Work Order ID 135667

Item Name: Replacement Skidtube (Fits LH or RH)

DRAWING NO. D2650	TITLE 206/407 SKIDTUBE ASSEMBLIES	REV. F	DART AEROSPACE LTD ENGINEERING ORDER		D.E.O. NO. D2650-F-1	SHEET NO. SHEET 1 OF 1	SCALE NTS
DRAWN <i>JP</i>	CHECKED <i>A.P.</i>	MFG. APPR. <i>AA</i>	APPROVED <i>HH</i>		DE APPR. <i>HH</i>		
DATE 12.10.12	DATE 12.10.22	DATE 12.10.22	DATE 12.10.22		DATE 12.10.22

CHANGE C'BORED WELDED CROSSBOLT SPACERS TO SWAGED SPACERS

DETAIL B

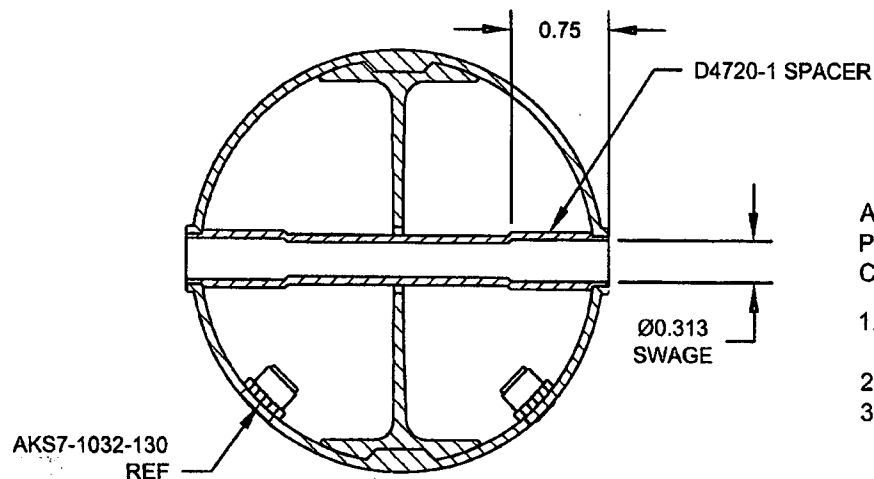
ADD DETAIL G BELOW, WHICH IS THE SAME SECTION VIEW AS DETAIL D OF DWG.
C'BORED HOLES ARE **NOW SWAGED** PER DETAIL G BELOW. FOR THE Ø0.375 HOLE THAT IS NOT C'BORED, WELD PER DETAIL D OF DWG (SEE AMENDED DETAIL B FOR REFERENCE).

D2649 SPACER,
WELD PER DETAIL D OF DWG
BUT DO NOT C'BORE

AMENDMENT TO DETAIL B
NOT TO SCALE

AFTER DRILLING AND BENDING ASSEMBLY
PERFORM THE FOLLOWING FOR Ø0.375 HOLES THAT ARE
CURRENTLY C'BORED:

1. INSERT D4720-1 SPACER, 16 PL (-1) OR 17 PL (-3)
OR 19 PL (-5) OR 23 PL (-7)
2. SWAGE TO Ø0.313 X 0.75 DP PER QSI 002
3. TRIM / GRIND FLUSH PER QSI 002

DETAIL G

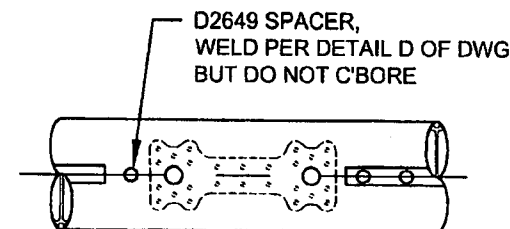
FOR Ø0.375 HOLES ONLY
FOR HOLES THAT ARE CURRENTLY C'BORED ONLY
NOT TO SCALE
